**REMARKS****RECEIVED  
CENTRAL FAX CENTER  
DEC 29 2006****I. INTRODUCTION**

Appln. No. 10/826,199  
Amdt. Dated: December 29, 2006  
Reply to Office Action of September 12, 2006  
Annotated Sheet Showing Changes

FIG. 3c

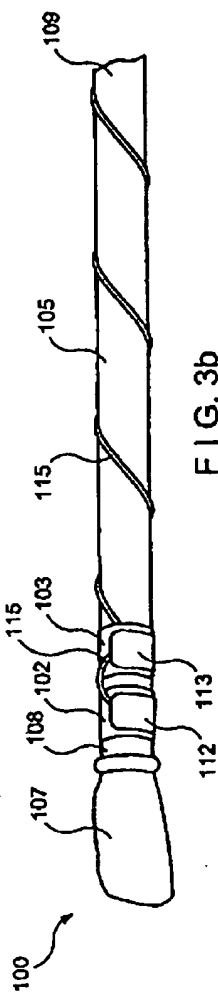
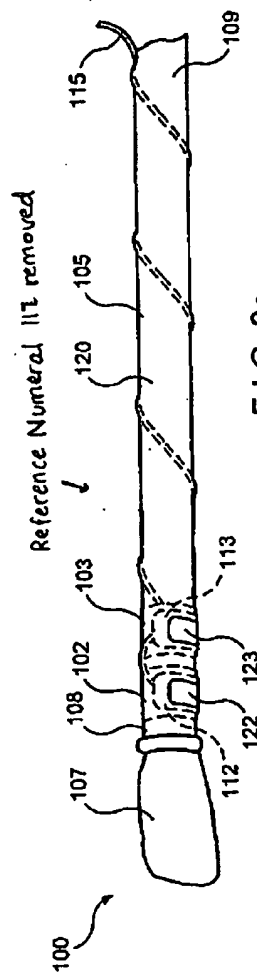
The attached sheet of drawings includes changes to Fig. 3c. This sheet replaces the original sheet including Figs. 3a-c. In Fig. 3c, the reference numeral 117 has been removed. An annotated sheet has been attached to show the changes made to Fig. 3c including an annotation stating the removal of the reference numeral 117.

The Examiner objected to the drawings because the drawings included a reference numeral that was not mentioned in the description. Specifically, Fig. 3a includes a reference numeral 117 that was not described in the specification of the present application. Fig. 3a has been amended to remove the reference numeral 117. A replacement sheet has been provided to replace Figs. 3a-3c. An annotated sheet has also been provided to show the changes made to Fig. 3c including an annotation stating the deletion of reference numeral 117. Thus, it is respectfully requested that the Examiner should withdraw the objection to the drawings.
